Docket Item # 4  
BAR CASE # 2010-0196

BAR Meeting  
September 22, 2010

**ISSUE:** Request for Approval of New Construction

**LOCATION:** 219 North West Street

**Figure 5: Elevations**  
**Submission September 22, 2010 BAR Hearing**

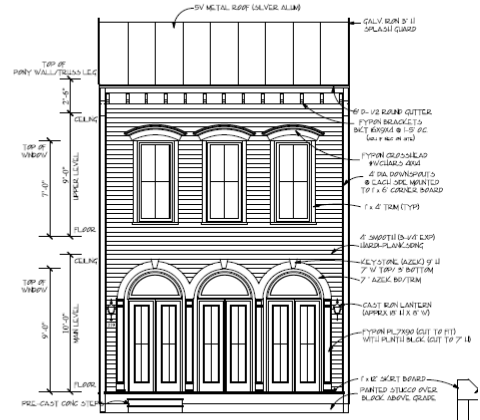
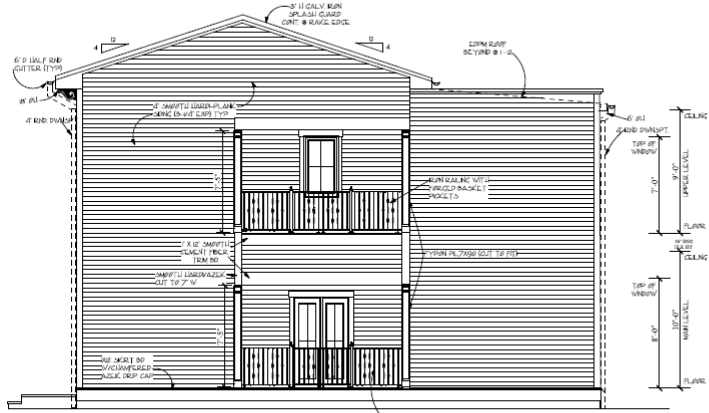
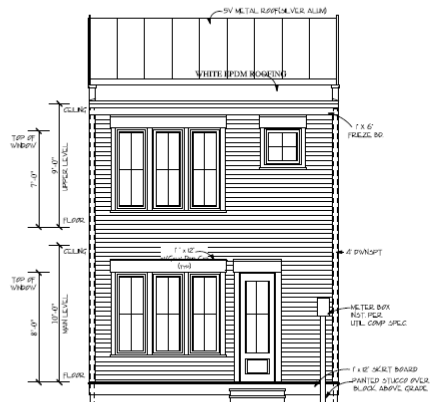
The design of the proposed townhouse was changed in response to comments at the last Board meeting. The applicant has provided images of several historic buildings nearby and in other portions of Old Town that were used as inspiration but, as recommended by the *Design Guidelines*, has not copied any of these directly. The previous false windows and vents have been removed from the side elevations and the detailing of the spandrel between the first and second floor of the side porch has been simplified and improved. The tripartite windows on the rear elevation have been aligned on the first and second floor, as the Board requested.

The major visual change is in response to the Board's concern about the character of the previous front door and window design. The tripartite Renaissance Revival arches with French doors now proposed are both simpler and slightly more formal than the previous design. The applicant has provided an example of this style façade treatment on North Saint Asaph St., though this townhouse is not historic and was constructed in the early 1990s.
